In Reply Refer To:
HSSD/CC-103A

This letter is in response to your request for the Federal Highway Administration (FHWA) acceptance of a modified trailer-mounted attenuator for use on the National Highway System (NHS).

| Name of system: | U-MAD Trailer-Mounted TMA |

Enclosure 1

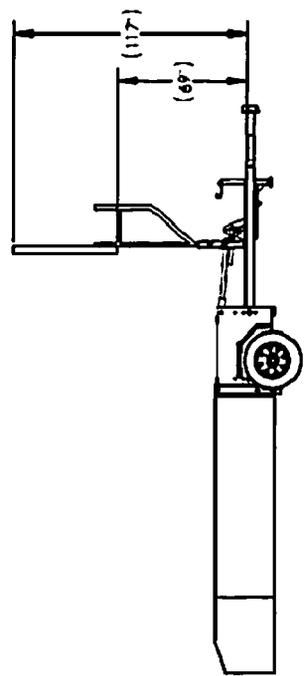
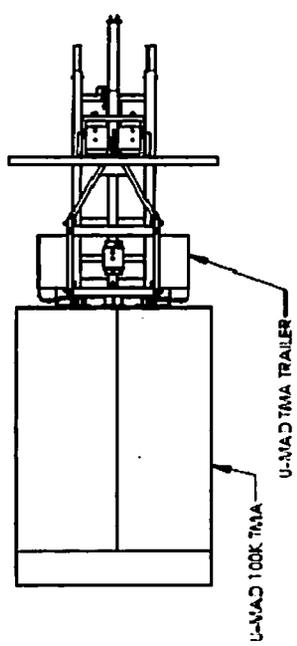
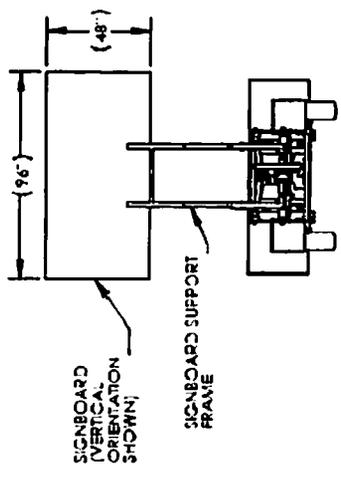
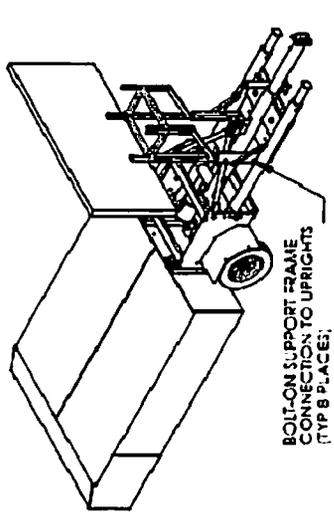
The basic U-MAD trailer-mounted attenuator described in detail in FHWA acceptance letter CC-103 was modified to add mounting brackets for a removable illuminated sign board assembly. Modifications to the trailer frame consist of two upright steel tubes and gussets welded to the trailer frame. The uprights are 3.5-inch x 2.5-inch x 3/16-inch (90-millimeter x 65-millimeter x 5-millimeter) steel tubes and the gussets are 1.5-inch x 1.5-inch x 3/16-inch (40-millimeter x 40-millimeter x 5-millimeter) steel angles. The sign support frame is made from 2-inch x 3-inch x 3/16-inch (50-millimeter x 75-millimeter x 5-millimeter) steel structural tubing designed to accommodate a 4-foot x 8-foot (1.2-meter x 2.4-meter) sign board. Enclosure 1 shows the modified trailer and Enclosure 2 shows the trailer with a TL-3 U-MAD cartridge and a sign board in place.

The design of the U-MAD trailer-mounted attenuator is such that an impacting vehicle is not likely to contact the trailer assembly when it is loaded with a TL-2 or a TL-3 U-MAD cartridge. The weight of the sign board and mounting hardware increases the total weight of the unit by approximately 12 percent. Your conservation of momentum analysis concluded that this minor increase in weight would not cause a significant increase in the occupant impact velocity reported in test 3-51 for the un-modified design. Your structural analysis further concluded that the sign board mounting structure and hardware is sufficient to withstand the maximum loads associated with an NCHRP Report 350 TL-3 impact. We have reviewed your analysis and agree with your conclusions.

Based on the considerations noted above, the FHWA agrees that the U-MAD trailer-mounted attenuator, as modified, remains acceptable as an NCHRP Report 350 TL-2 or TL-3 attenuator.
